W3F1-2010-0032

November 23, 2010

Subject: Response to Request for Additional Information Regarding Final Supplemental Response to Generic Letter 2004-02, Potential Impact of Debris Blockage on Emergency Recirculation During Design Basis Accidents at Pressurized-Water Reactors (TAC No. MC4729) Waterford Steam Electric Station, Unit 3
Docket No. 50-382
License No. NPF-38

Response to Request for Additional Information

Figure 16-1: Containment Spray Distribution to Safety Injection Sump

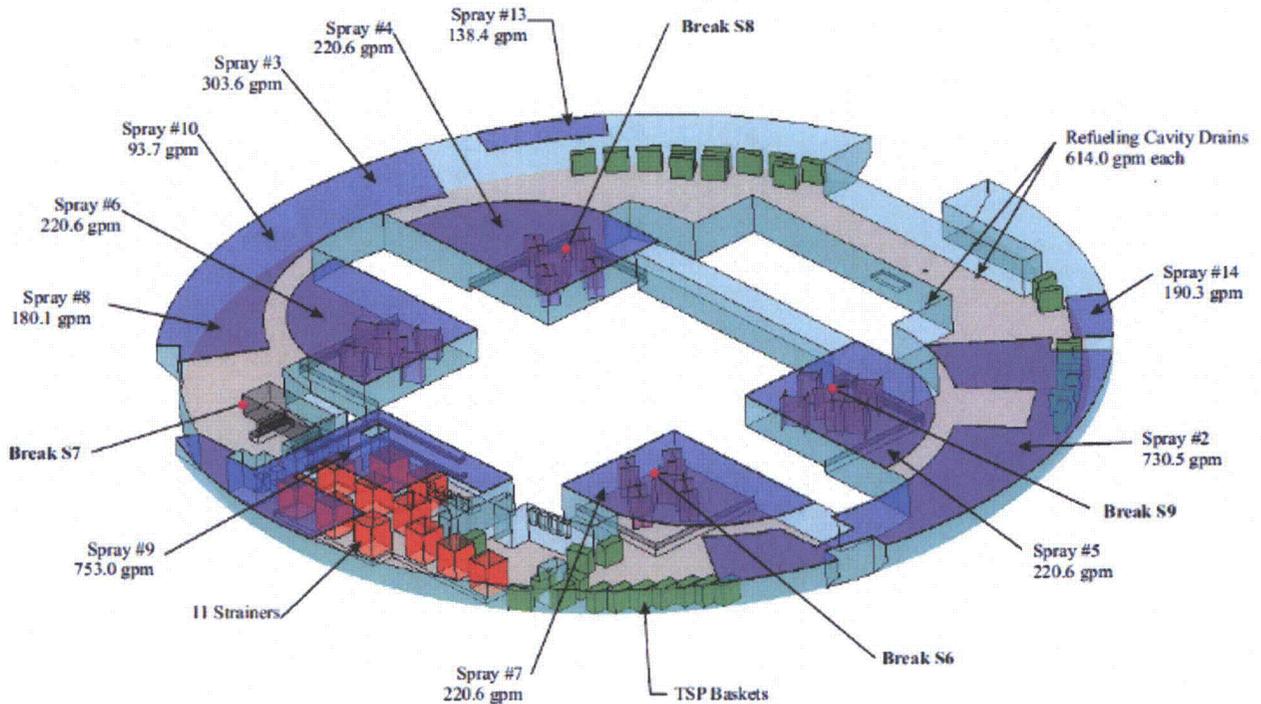
Please identify the distance from the strainer at which debris was added to the test flume and justify the conservatism of this distance based on the transport analysis results for blowdown, washdown, and pool-fill transport. Please specifically discuss consideration of the debris addition in the head loss testing for the fraction of paint chips and other containment debris that would have the potential to wash down onto the strainers from upper containment elevations, and would thus not have to climb over the suction plenum to reach the strainer surface.

All but one break are at a significant distance from the sump. For the S7 break, which is closest to the sump, a concrete wall separates blowdown from sump. Wash down would only come from Containment Spray in a very limited area over the sump; see Figure 16-1. Transport fractions are based on all debris starting on containment floor at the break location. The top of the Waterford 3 strainers are solid such that debris falling directly on the strainer will not block flow.

Figure 23-2: Isometric Layout of Test Tank and Strainer (Return header is not shown)

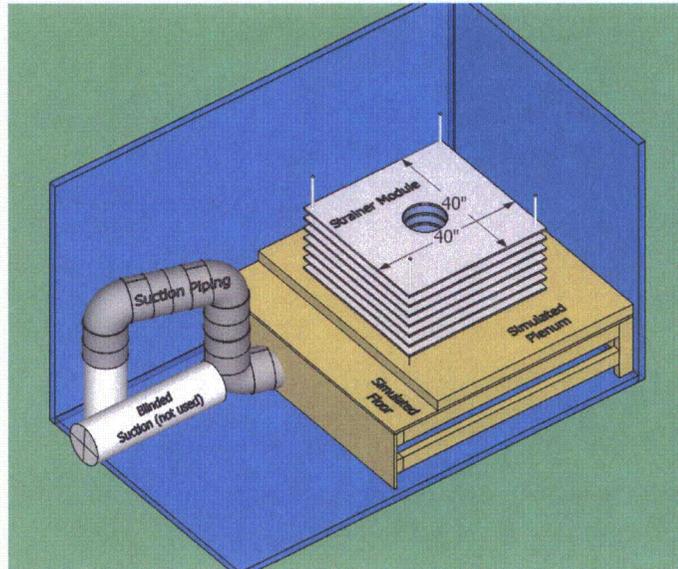
Please provide a general description of the emergency core cooling system (ECCS) strainer head loss testing conducted after the Waterford 3 audit, including the scope of the test program, a general description of the overall concept of how the testing addressed the audit issues, the location of the testing, and other relevant issues associated with the broad test program. Adequate details on the test procedures are necessary for the NRC staff to reach conclusions regarding their adequacy. Please include the following information:

12. The tank was drained and cleaned.
- c. A small-scale plant model with one sump strainer module was created in the test pool. The model included the plenum and one test module with a width and length matching

the plant strainer design but with 7 disks rather than the plant design of 17. An isometric drawing of the layout is included as Figure 23-2.

Figure 27-1: Thin Bed Test Smoothed Data and Logarithmic Curve Fit

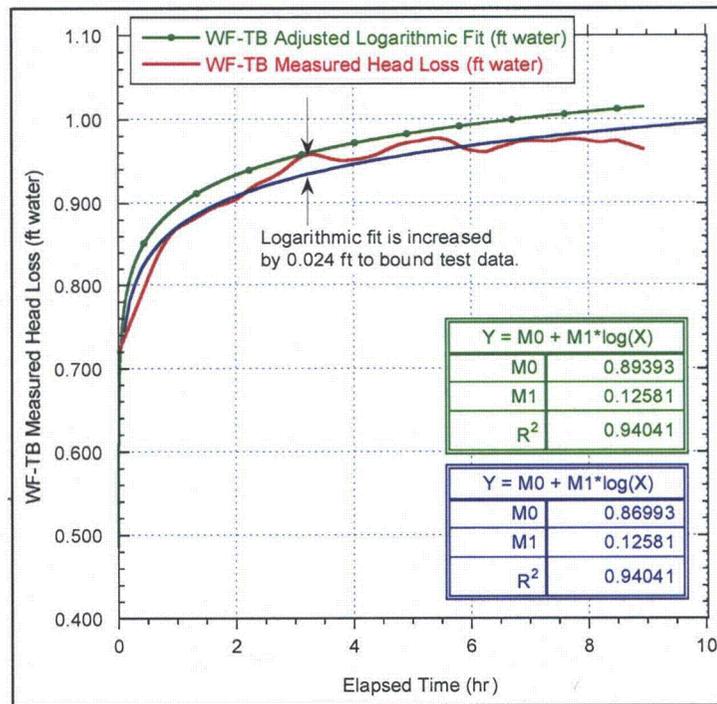
Please provide and justify the method for extrapolation of test results to mission times for the post-audit tests. Note that the tests reviewed during the audit were found to have acceptable final values. Therefore, if the same approach was used during the later testing, and similar head loss trends at the end of the test were observed, a statement to that effect will suffice.

The Alion test termination criterion allows for an increase of less than 1% over a one hour interval at the completion of the test, resulting in test durations of less than 30 days. A natural logarithmic decay expression is fit to the end of test data (from final debris addition to termination criteria met), then a positive head loss offset is added to the expression to bound all measured head loss for that particular test. A sample of the logarithmic fit to test data is included as Figure 27-1.

Using the resulting logarithmic curve fit expression; the head loss at 30-days (720 hours) was then extrapolated. In one case where the maximum measured head loss was not at the end of the test (WF3-FL), the data prior to the maximum measured head loss was used rather than the end of test data to ensure that the extrapolated head loss was conservative.

Figure 33-1: Containment Pressure Profile Based on Maximum Temperature

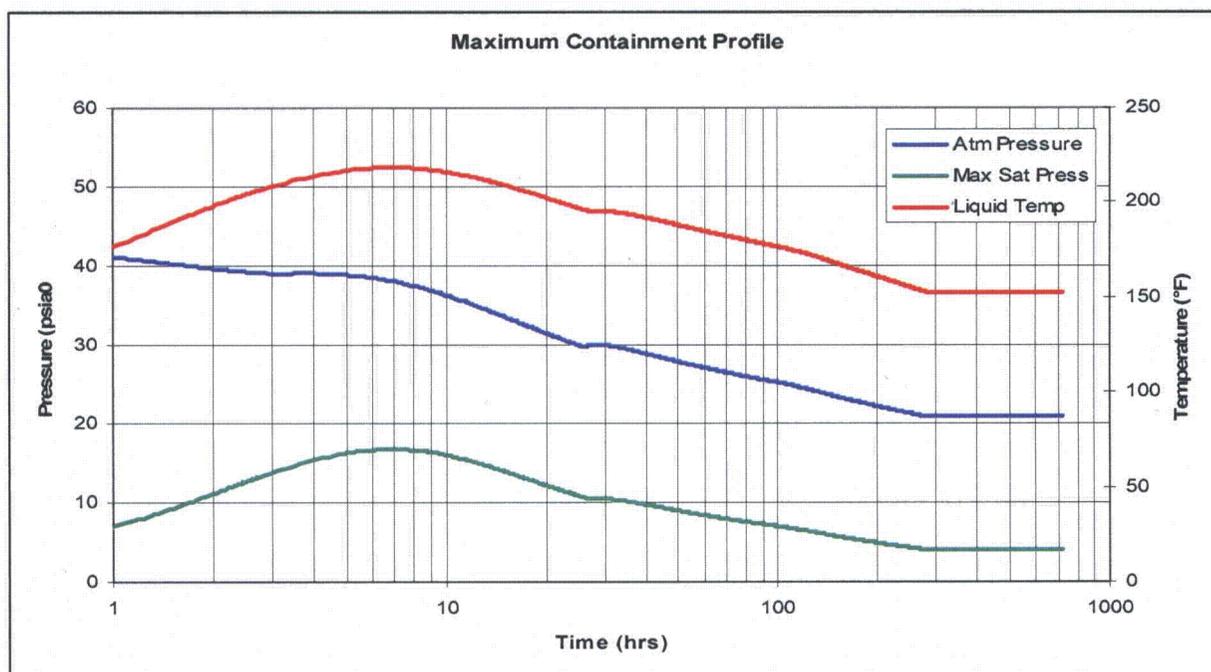
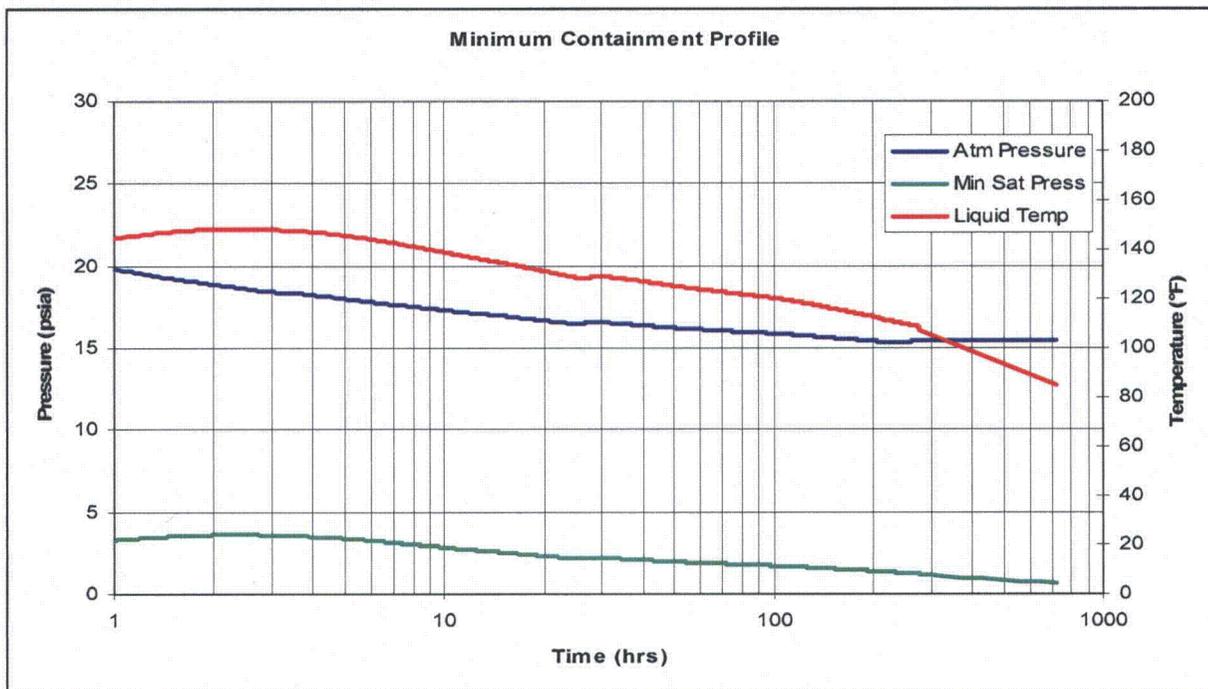
The supplemental response dated October 23, 2008, stated that flashing at the strainer would not occur because the strainer submergence is 8 inches and the maximum head loss is about 6 inches. This is true for a large-break LOCA, but does not address a small-break

LOCA, which has a bounding submergence of about 2 inches. Please provide an evaluation for flashing during a small-break LOCA at the most limiting condition. This may require an evaluation of head loss versus submergence over time or credit for accident-generated pressure.

Credit for 1 psi of containment overpressure will provide > 2 ft flashing margin when submergence is less than the bounding head loss. Sump temperature will reach 210 °F at about 2.2 hrs after Recirculation Actuation Signal and exceed 210 °F for only about 11 hrs during the event. The maximum temperature profile is based on; (1) 1 of 2 Containment Spray Trains operating, (2) 1 of 4 Containment Fan Coolers operating, and (3) minimum Safety Injection flow. Waterford 3 Technical Specifications require containment pressure to be maintained between 14.275 psia and about 1 psig (27 inches water).

When expected containment pressure is compared to the saturation pressure of the sump fluid throughout the duration of an event it can be seen that adequate margin exists to support the 1 psi overpressure credit. Two cases are presented below. Figure 33-1 shows the comparison for the maximum sump temperature evaluation. Figure 33-2 shows the comparison for the minimum sump temperature evaluation.
